A6 to Manchester Airport Relief Road (A6MARR)
Response to Submission by Poynton Against Unnecessary Links to the
Airport (PAULA) – July 2013

This paper provides the A6MARR Project Team's response to PAULA's submission to the Phase 2 consultation on the A6MARR.

Figure 7.5: SEMMMS Recommended Strategy: Selected Infrastructure Elements

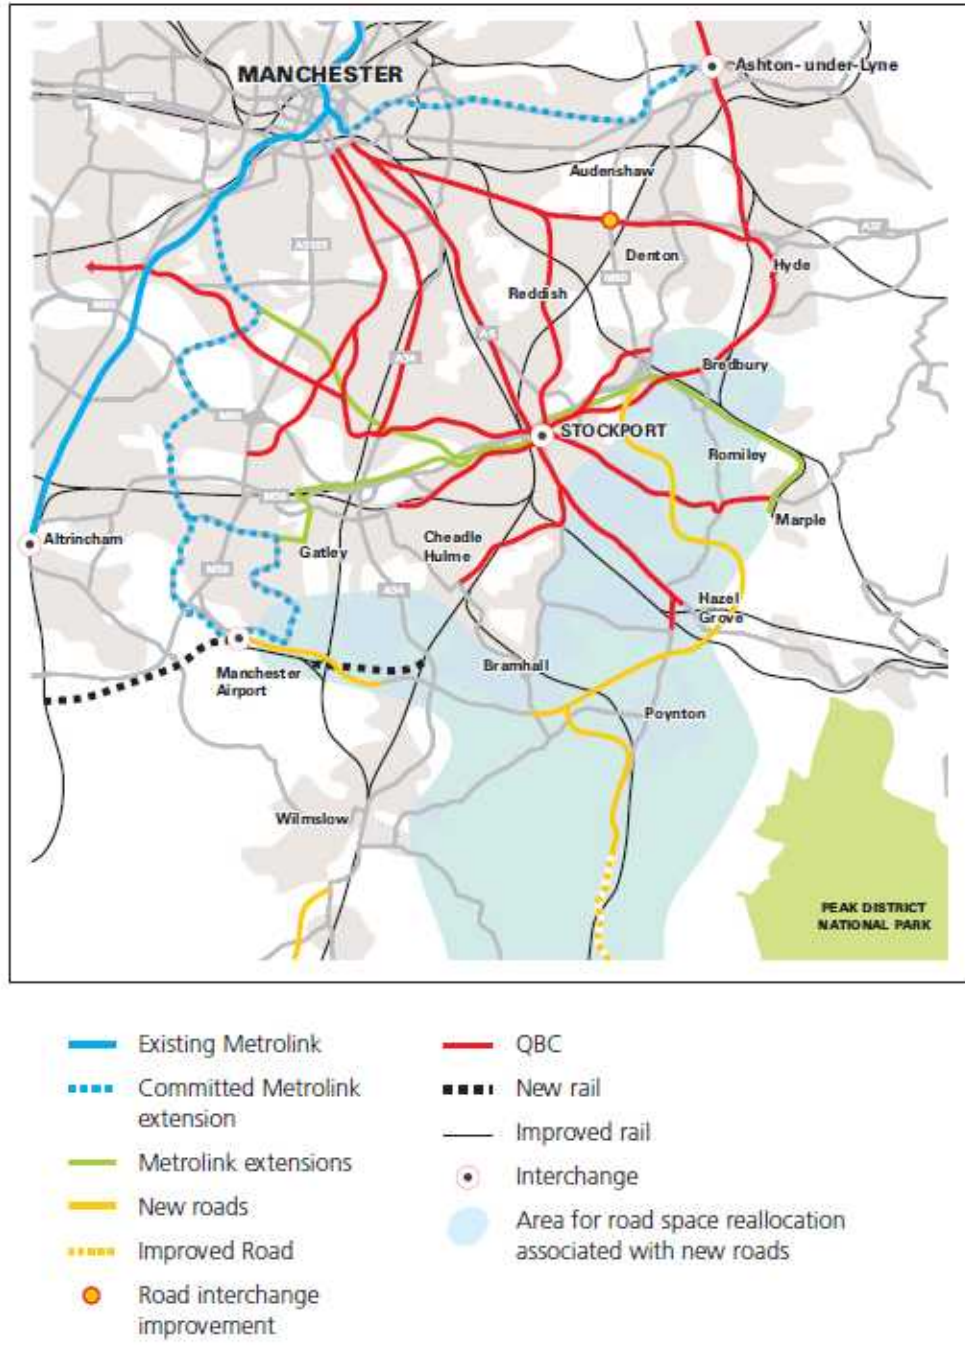
9.1) SEMMMS defends this position by claiming the modal mix was decided in 2001 before SMBC took the lead. We think SEMMMS could have been far more imaginative over the last 12 years and should have achieved a far more balanced modal mix. From 2001, SEMMMS spent no significant effort analysing the benefits of alternative modes.

-no WebTAG analysis was carried with and without the SEMMMS cycleway

-or for the Metrolink into Hazel Grove

-or for heavy rail from Stockport to the Airport

-only a WebTAG analysis with and without the road was carried out

With reference to the infrastructure elements of the SEMMMS recommended strategy illustrated in Figure 7.5 of the Final Report and re-produced below, it should also be noted that it is very clear that none of the other recommended elements of the strategy actually cover the same corridor as the recommended road schemes. In fact, the recommended road schemes are the only infrastructure proposals in this corridor. The road schemes were an integral part of the SEMMMS recommended strategy.
